APPLICATION NO.	FILING DATE	FIRST NAMED INVENTOR	ATTORNEY DOCKET NO.	CONFIRMATION NO.
10/065,772	11/18/2002	Hwang Choe	24-NS-6042	2406
23465 7590 04/03/2007 JOHN S. BEULICK C/O ARMSTRONG TEASDALE, LLP ONE METROPOLITAN SQUARE SUITE 2600 ST LOUIS, MO 63102-2740			EXAMINER GREENE, DANIEL LAWSON	
			ART UNIT 3694	PAPER NUMBER
SHORTENED STATUTORY PERIOD OF RESPONSE		MAIL DATE	DELIVERY MODE	
3 MONTHS		04/03/2007	PAPER

Office Action Summary	Application No. 10/065,772	Applicant(s) CHOE ET AL.	
	Examiner Daniel L. Greene Jr.	Art Unit 3694

DETAILED ACTION

Fig. 2

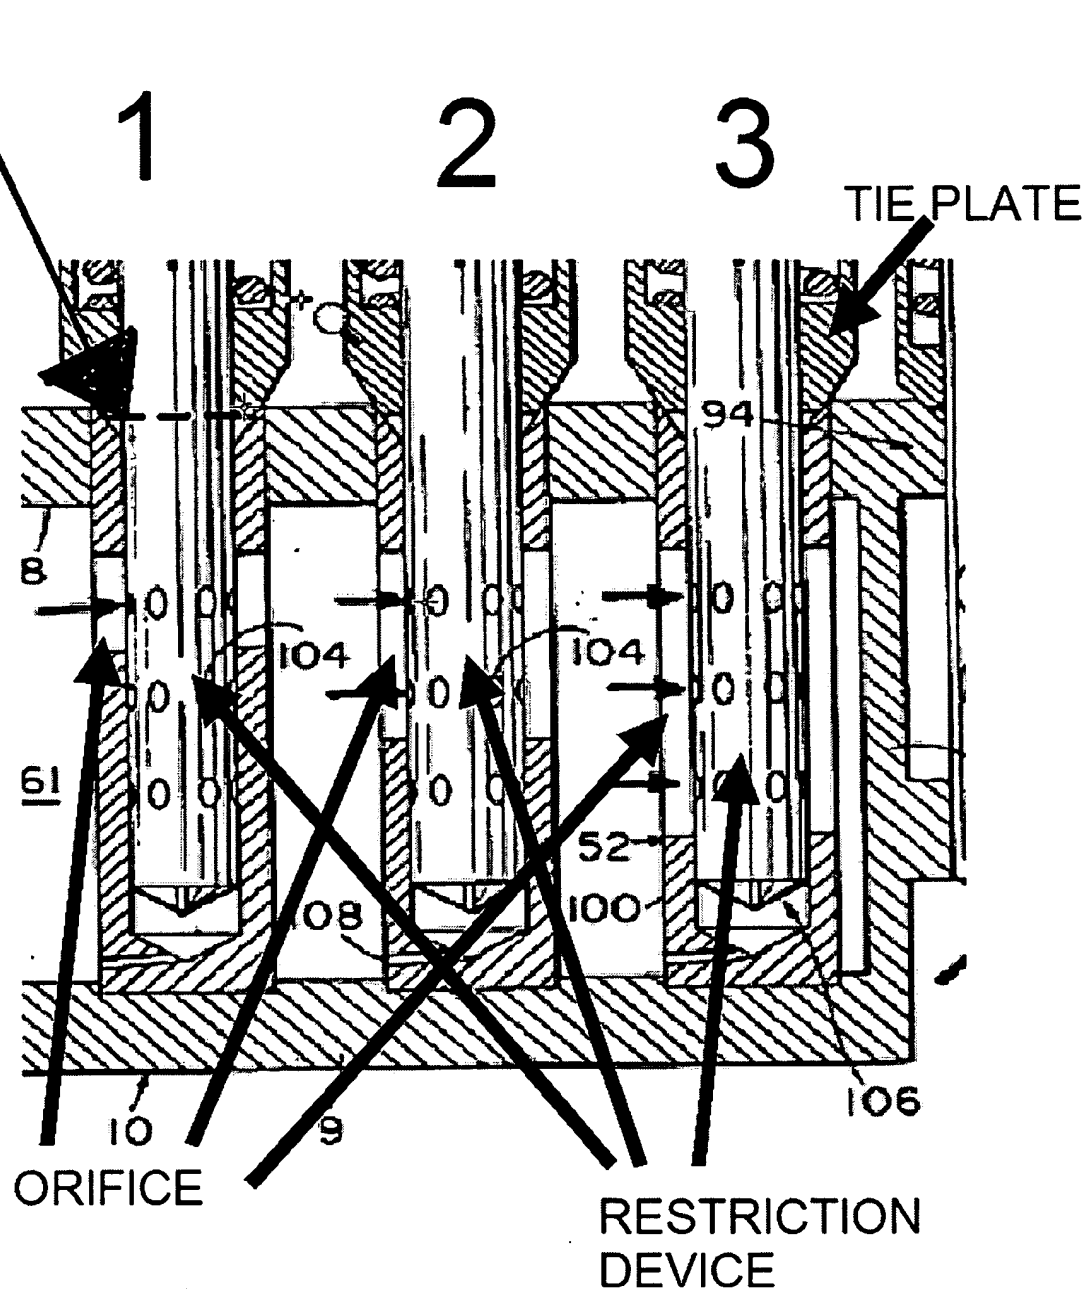
Resort will be had to Figure 2 to set forth the structural limitations

First, the Examiner would like to point out that after further consideration it has been determined that Patterson does indeed set forth three core flow regions because as shown by Figure 2 below, the flow through EACH radial blanket fuel assembly the examiner has labeled as 1, 2 and 3 will indeed be different due to the different size of the orifice that lets water into each said fuel assembly.

Second, as clearly indicated by the Examiner, each radial blanket fuel assembly does indeed have its own restriction device that is indeed detachably coupled to the lower end of the lower tie plate as the limitation "detachably coupled" is encompassed by using a cutting torch to detach said restriction devices from the lower tie plate as evidenced by the words "cut along dotted line to detach restriction device"

CUT ALONG DOTTED LINE TO DETACH
RESTRICTION DEVICE

Indeed, it appears some of the issues with determining exactly what Applicant is attempting to claim is due to the failure of the drawings to show exactly what applicant's invention is. However the limitation "detachably coupled" is really an intended use or how the applicant would like the restriction device to be attached. There is nothing that would prevent anyone from cutting off the restriction devices of Patterson, that is to make them detachably attached.

Yasuyaki was cited to show flow through three regions of the core was obvious to do and as such was simply redundant because, as set forth above, Patterson does indeed set forth three different flow rates controlled by orifices of three different sizes.
